Paper for consideration by IHO DIPWG4 meeting, Monaco May 2012

ECDIS anomalies Clarifications, changes and test material needed

Alarms and indication from IHO CDS

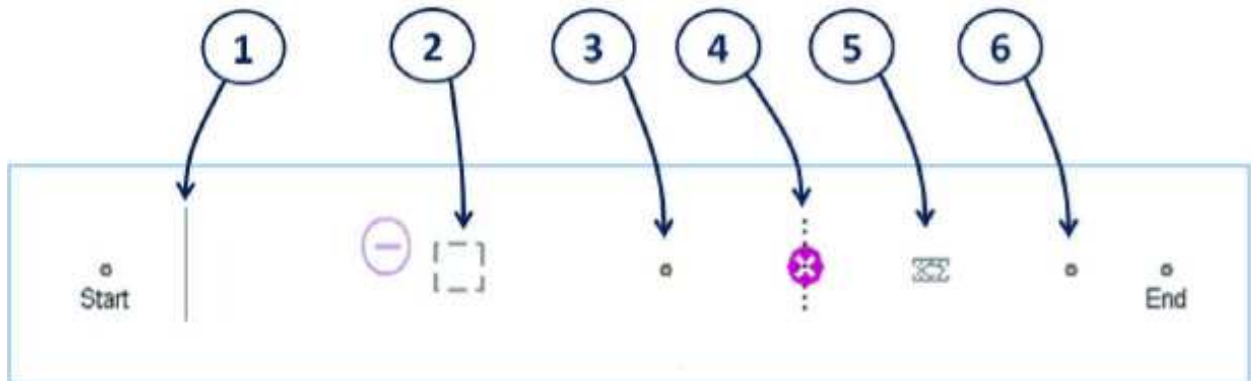
I select as example number 2, which is TESARE with RESTRN set as 14. This example in the IHO CDS told everybody that information available in the Use of Object Catalogue cannot be used to select correct object attribute combination for alarms and indications, because USOC specified that area to be avoided is coded as RESARE with RESTRN set as 14. The IHO CDS extended the “area to be avoided” to include every object which is allowed to have attribute RESTRN.

AA3TEST1

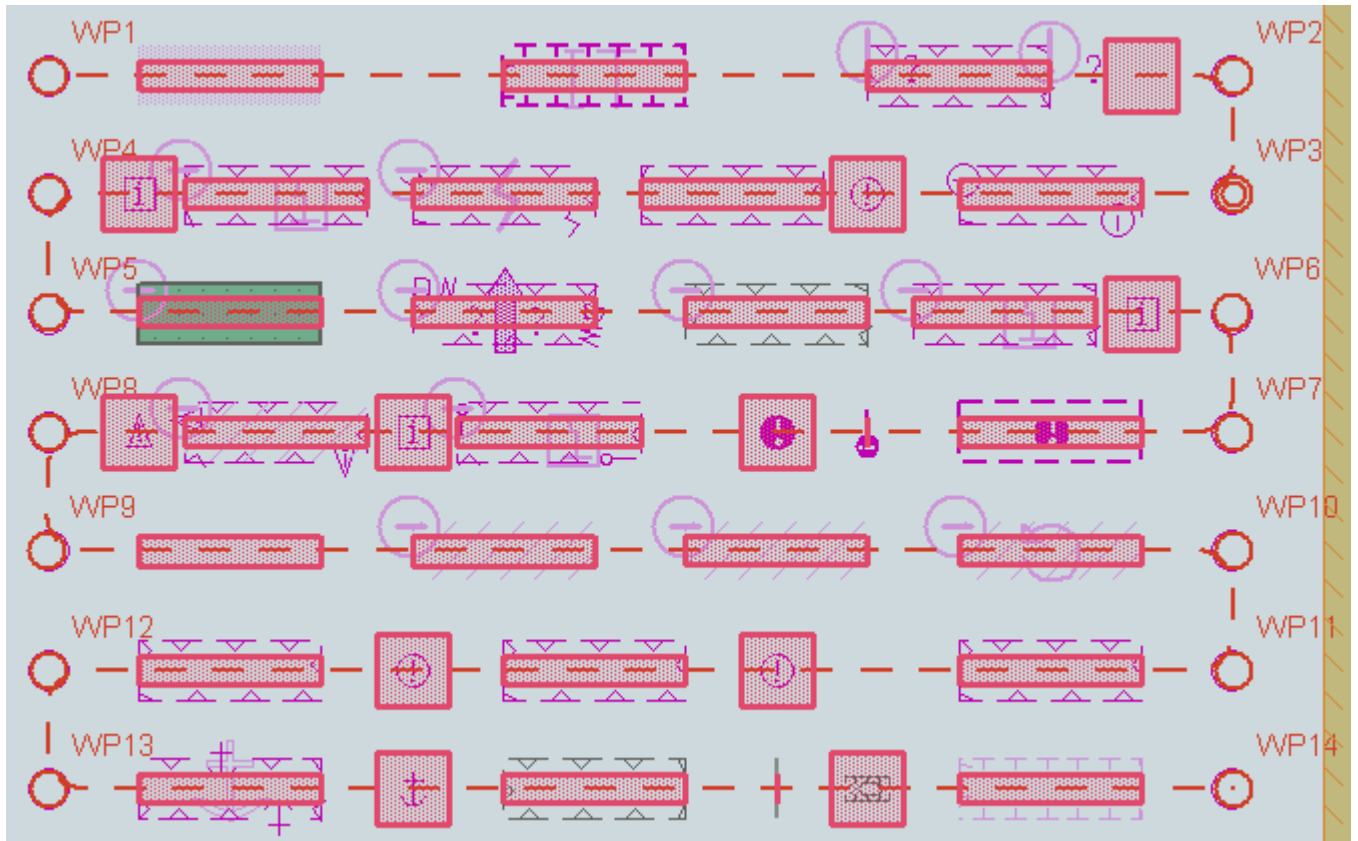
As evidence of the work already done by the group below is example of the style of the 2 new test cells
